PLANNING COMMISSION AGENDA

PLANNING COMMISSION STAFF REPORT

Public Hearing
Proposed Zone change
Applicant: Duane Johnson
Location: approximately 742 East Old Fort Road
Acreage: approximately 13.86 acres

5. Meadows Rezone

Concept Plan

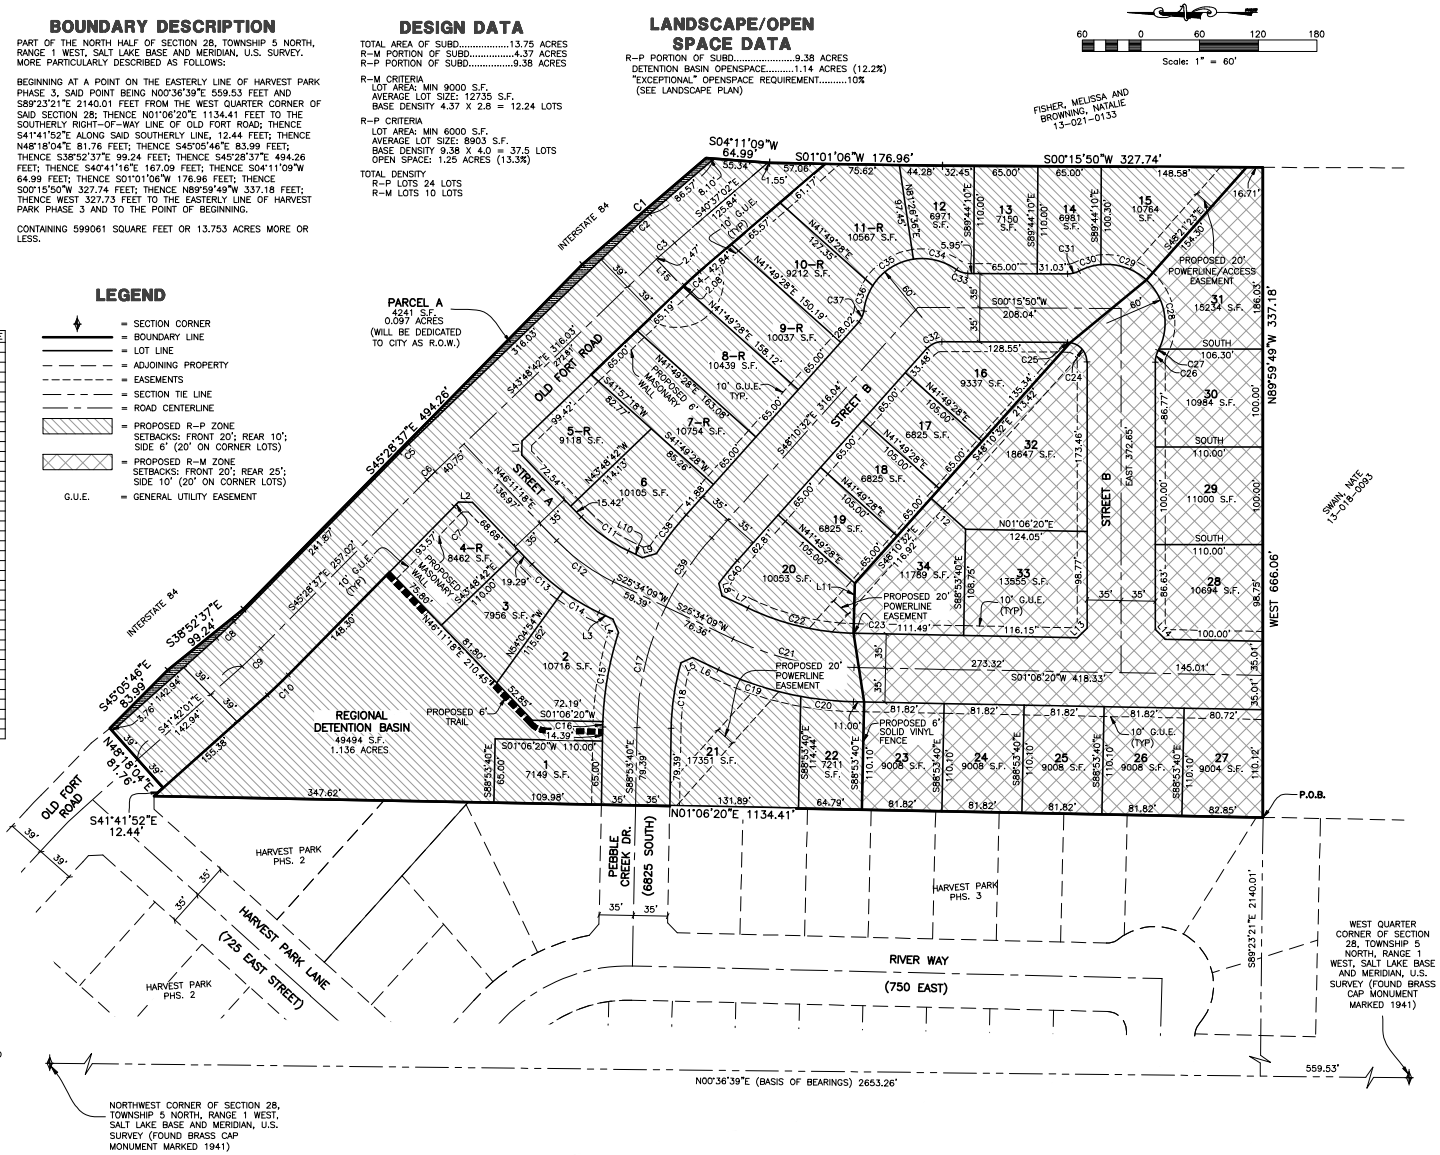
The General Plan Projected Land Use Map identifies approximately 10 acres at the northern portion of the property as R-P, the remaining property is designated for moderate density. The moderate zoning district portion is consistent with the General Plan land use designations for the property. The applicant requested 9.375 acres to be rezoned to the R-P zone. However, the R-P zone is not recommended unless an amenity is included in the project. As stated in the General Plan, this density requires additional amenity or benefit to the city to be approved.

The applicant submitted a Cost Share agreement, but there is little suggested as an improvement or benefit to the city to justify the increased density.

The traffic impacts of the potential development will be analyzed in detail during the subdivision process. However, the South Weber Vehicle Transportation Map shows that an east/west collector roadway is required to provide a road connection to the west and east of the project. Old Fort Road should be extended to accommodate additional traffic for potential development. A north/south collector road is also required by the general plan, connecting the Old Fort Road on the north to the future extension of Canyon Drive. These travel corridors as required by the General Plan will provide additional travel routes and distribute the traffic load on to multiple roadways and lessen the overall transportation impact while providing additional routes for emergency services.

The proposed zone change does not meet the goals and objectives of the General Plan as stated in the staff report. Staff recommends denial of the zone change for the 13.86 acres from A (Agricultural Zone) to R-M (Residential Moderate Density Zone on 4.379 acres) and R-P (Residential Patio Zone on 9.375 acres) on approximately 13.86 acres total.

SHEET: C-2

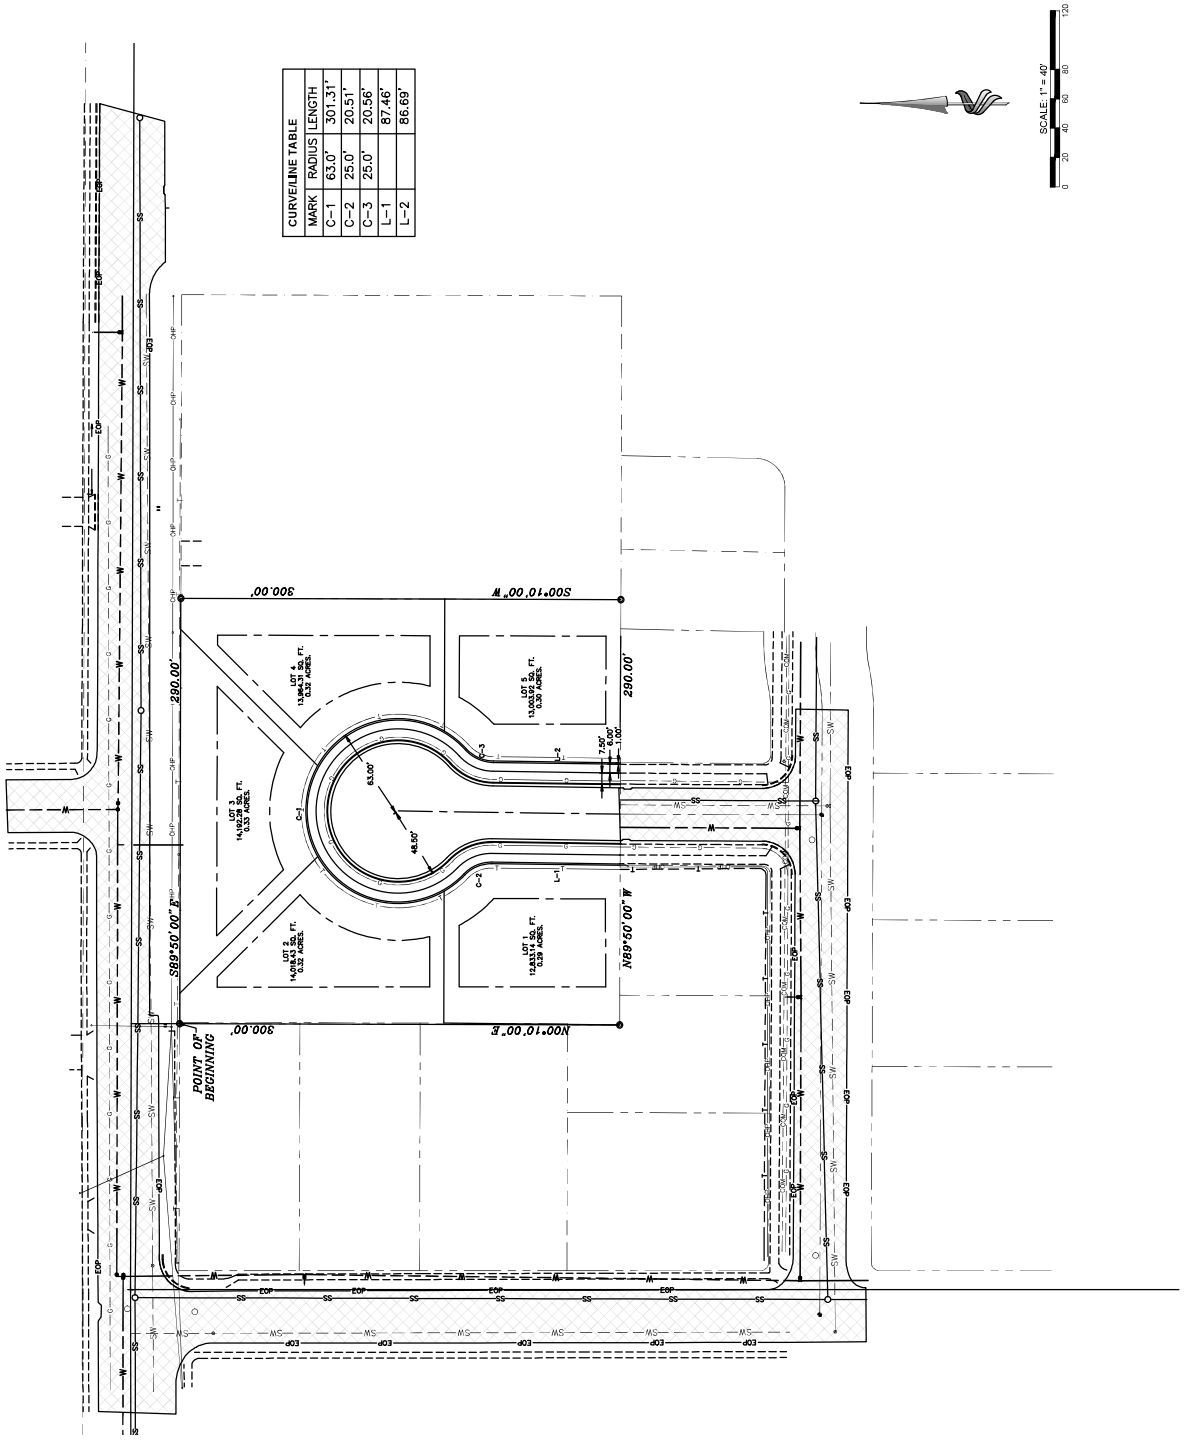
Engineering Comments: The City Engineer reviewed the Namazi Preliminary Plat and recommends preliminary plat approval based on the modifications required in his review memo.

COTTONWOOD ESTATES
PRELIMINARY PLAT - 'NOT TO BE RECORDED'

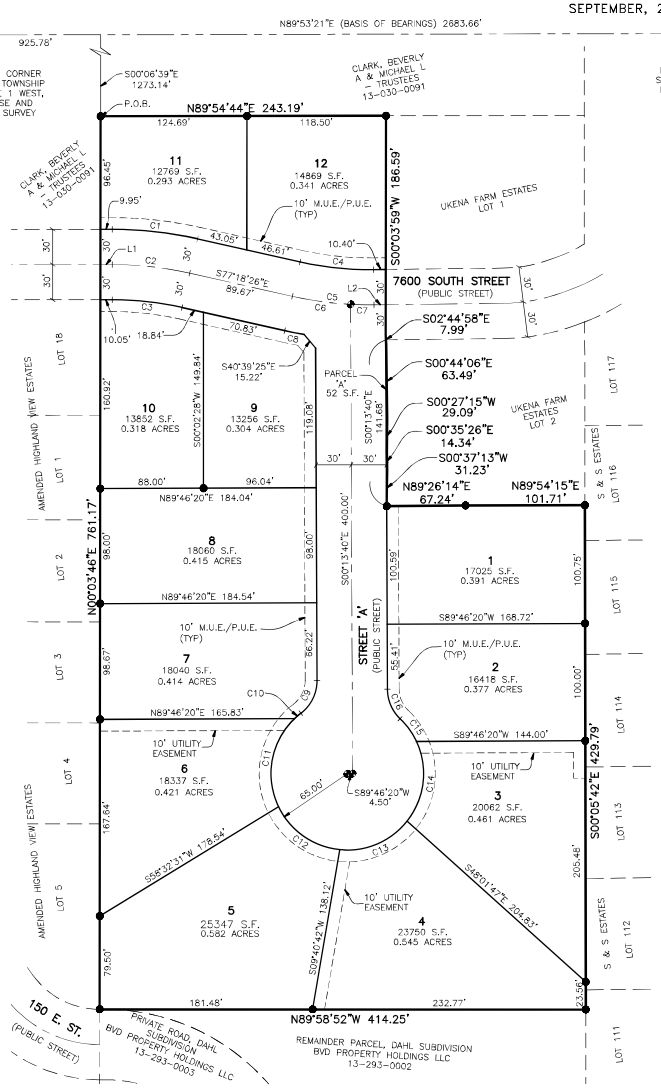
Engineering Comments: The City Engineer reviewed the Kap Legacy Preliminary Plat and recommends preliminary plat approval based on the modifications required in his review memo.
